## **SCOPING OPINION:**

# **Proposed Stanlow Hydrogen Ready Modular Combined Heat and Power Project**

**Case Reference: EN0110007**

**13 October 2026**

Figure 1: NGET Assets in proposed development area

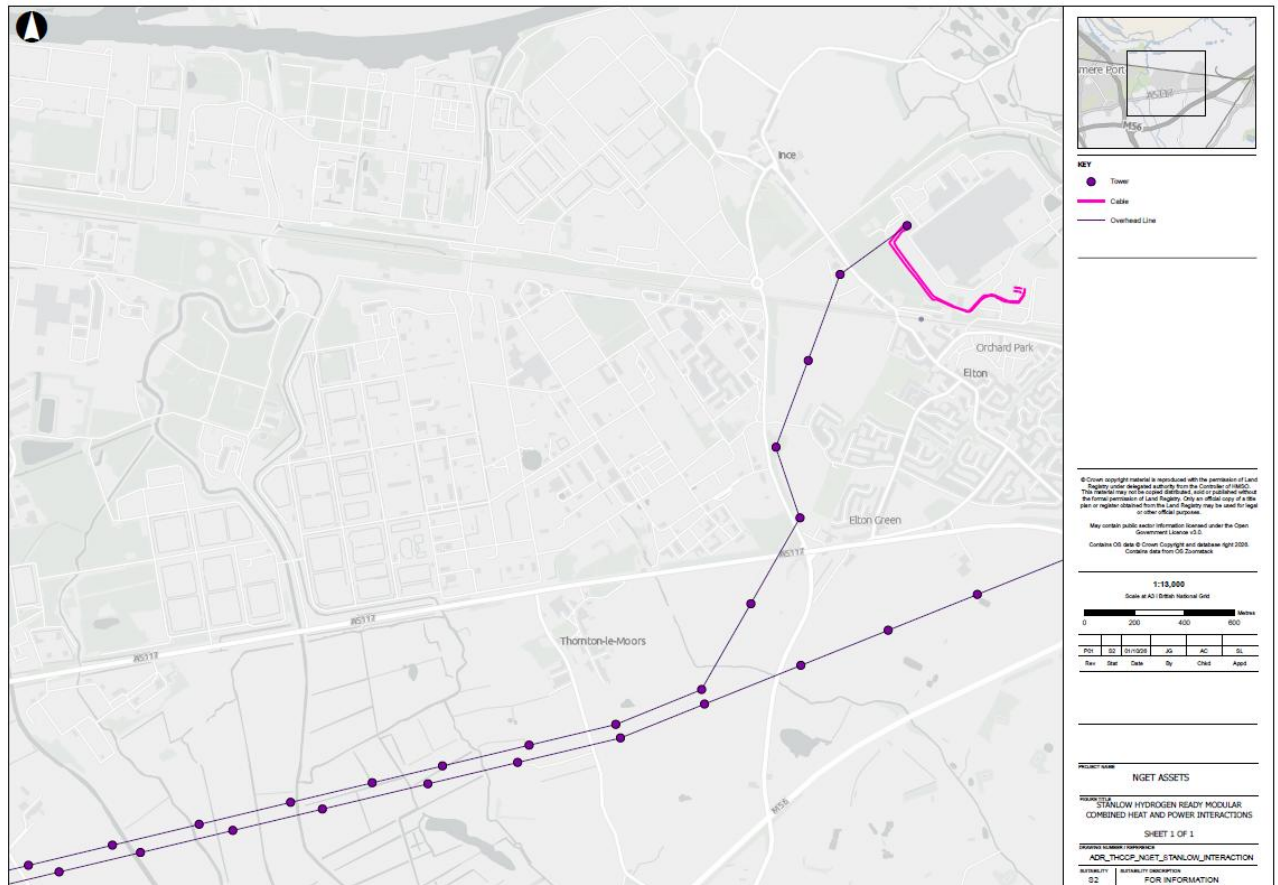
We enclose a plan showing the location of NGET's apparatus in the scoping area.
